# Access Compliance Report

## Public Rights-of-Way

### (Curb Ramps)

Intersection ID: 48943	Main Street: CALDWELL RIDGE PY	Cross Street: MORGAN LEE AV	Location: NE
ADA ID: 937F24DE936C	Ramp Type: BlendTrans1	Initial Pass/Fail: Fail	Overall Compliance: No
Severity Score: 10			
Codes/Mitigation Info/Possible Solution		Field Measurements/Component Compliance

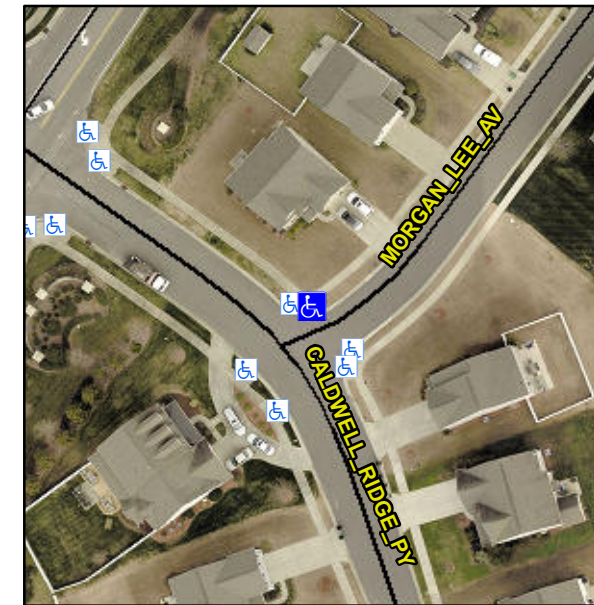
**Remove & Replace Curb Ramp With Two New Directional Ramps or Equivalent.**

**Not Found, R304.5.1, R304.5.3**

Compliance	Description	Data	Compliance	Description	Data
N/A	Ramp Length (in)	71.0	Yes	BlendTrans Slope (%)	2.2
No	Ramp Width (in)	47.5	No	BlendTrans XSlope (%)	2.9
N/A	Flare Type LT	N/A	N/A	Flare Type RT	N/A
N/A	Flare Slope LT (%)	N/A	N/A	Flare Slope RT (%)	N/A
N/A	Flare Traversable LT?	N/A	N/A	Flare Traversable RT?	N/A
N/A	Landing Length (in)	N/A	N/A	DWS Provided?	N/A
N/A	Landing Width (in)	N/A	N/A	DWS Contrast?	N/A
N/A	Landing Slope (%)	N/A	N/A	DWS Length (in)	N/A
N/A	Landing X Slope (%)	N/A	N/A	DWS Full Width?	N/A
N/A	Landing Curb? (Y/N)	N/A	N/A	DWS Offset (in)	N/A
N/A	Shared Landing?	N/A			
N/A	Gutter Ponding?	N/A	N/A	Gutter Slope (%)	N/A
N/A	Gutter Lip Ht (in)	N/A	N/A	Gutter X Slope (%)	N/A
N/A	Painted X Walk1?	No	N/A	Painted X Walk2?	N/A
	X Walk 1 Direction	To SE		X Walk 2 Direction	N/A
	X Walk 1 Width (in)	N/A		X Walk 2 Width (in)	N/A
	X Walk 1 Slope (%)	1.7		X Walk 2 Slope (%)	N/A
	X Walk 1 X Slope (%)	1.4		X Walk 2 X Slope (%)	N/A

N/A	Ramp inside XWalk1?	N/A	N/A	Ramp inside XWalk2?	N/A
	Road Slope (%)	1.4		Clear Space?	N/A
	Road X Slope (%)	1.7	N/A	Clear Space to XWalk (in)	N/A
N/A	Any Obstructions?	N/A	N/A	Storm Grate/Utility Hazard?	N/A
	Obstruction Type			Storm Grate/Utility Type	
		N/A			N/A
			Yes	Surface Condition? (G/P)	Good
			No	Curb Slope (%)	12.5
